# UNITED STATES PATENT AND TRADEMARK OFFICE

APPLICATION NO.	FILING DATE	FIRST NAMED INVENTOR	ATTORNEY DOCKET NO.	CONFIRMATION NO.
10/765,117	01/28/2004	Goran Pantzar	024445-446	9711
55694	7590	10/11/2005	EXAMINER	
DRINKER BIDDLE & REATH (DC)			ROSS, DANA	
1500 K STREET, N.W.			ART UNIT	
SUITE 1100			PAPER NUMBER	
WASHINGTON, DC 20005-1209			3722

**Office Action Summary**

## **DETAILED ACTION**

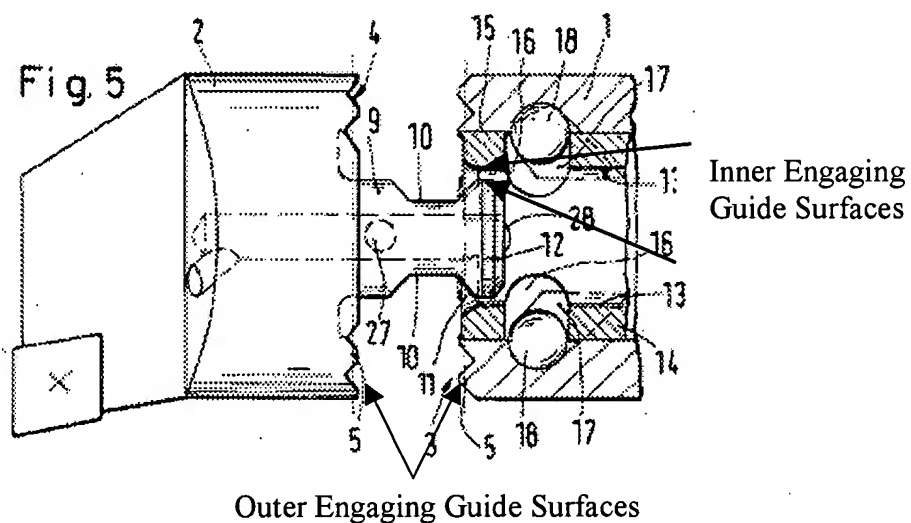
5. Claims 1-8, 11 and 14 are rejected under 35 U.S.C. 102(b) as being anticipated by US Pat. No. 4,655,655 (Schürfeld, hereafter ‘655).

‘655 teaches a tool and workpiece holding arrangement with the first and second tool holders (see area of reference numbers 1 and 2 of figure 1) being clamped together in an axial direction by a force applying member (see figures 5 and 6, and reference numbers 18, 14, for example); the first body including an axially extending male part 9,10, the second body including an axially extending female part (see figure 5, area between walls 13) in which the male part is

received (see figure 5); first and second guide structures (see figure 5 below) for guiding the structures in the radial direction, the first guide structure with radially outer engaging guide surfaces with ridges and grooves and the second guide structure with radially inner guide surfaces (see figure 5 below); the inner guide surfaces with a cylindrical projection and cylindrical recess of complementing shape (see figure 5 below).

Regarding claim 5, though '655 does not expressly disclose the groove 5 has a radius of curvature larger than the radius of curvature of the ridge 5, it is inherent that the groove 5 has a radius of curvature larger in order for the ridge to fit within the groove (see figure 6, for example).

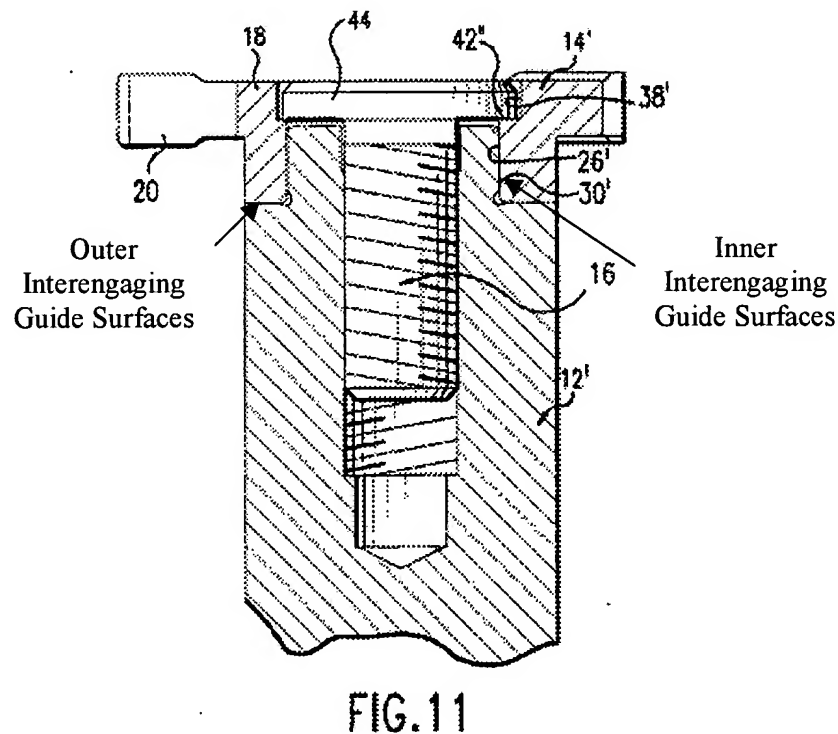
6. Claims 1 and 8-14 are rejected under 35 U.S.C. 102(b) as being anticipated by US Pat. No. 5,607,263 (Nespeta et al., hereafter '263).

'263 teaches first and second bodies 14, 12 (see figure 4, for example), the first tool body 14 with a male member (area 22 of figure 4) and the second tool body 12 with a female member (area 50 of figure 4); outer and inner interengaging guide surfaces (see fig. 11 below); the male and female parts having a generally triangular cross section (see figures 1 and 3, for example); a force applying screw 16 (see figure 4, for example).

Regarding claim 13, figure 4 shows a chamfer above the threaded portion of the screw 16.
